PCCO No. 2
9/12/2023

Project: McKinney TKI ET

The Contract is changed as follows: PCO02

RE: PCO02 Narrative

Project: McKinney TKI – Temp Tunnel

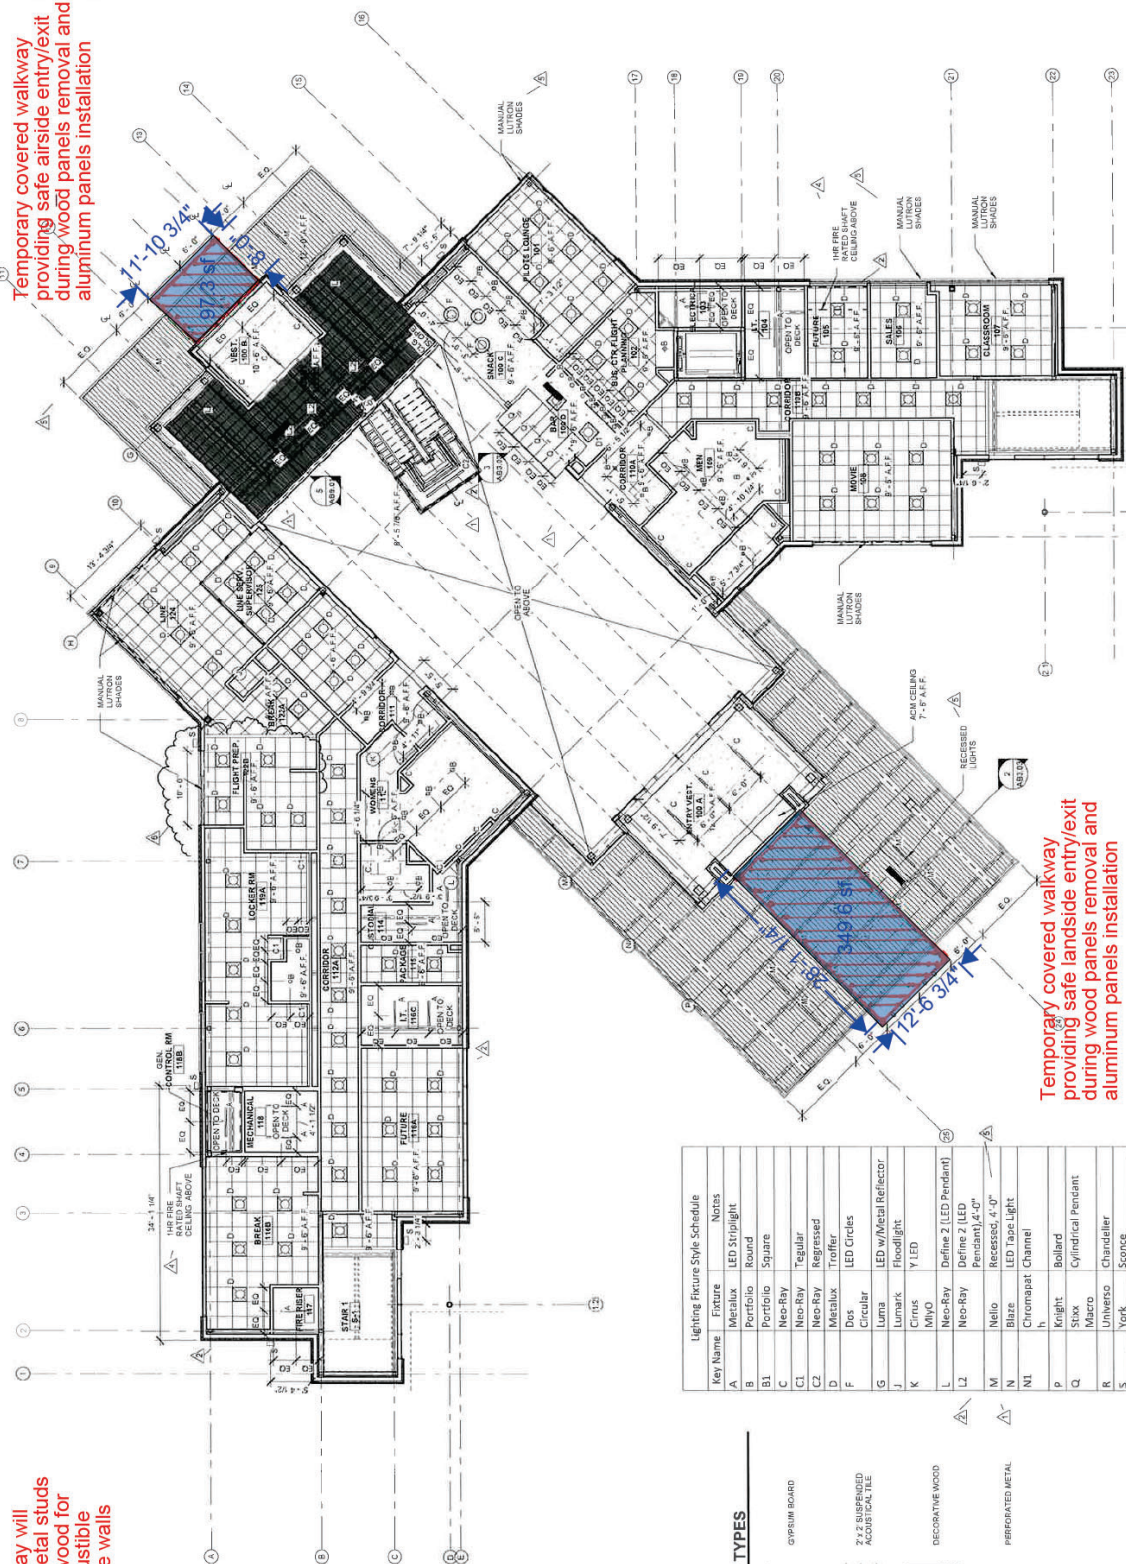
Temporary covered walkway providing safe airside entry/exit during wood panels removal and aluminum panels installation

Temporary covered walkway will be constructed of 3-5/8" metal studs with 3/4" fire retardant plywood for the top and 5/8" noncombustible DensGlas sheathing for the walls

Temporary covered walkway providing safe airside entry/exit during wood panels removal and aluminum panels installation
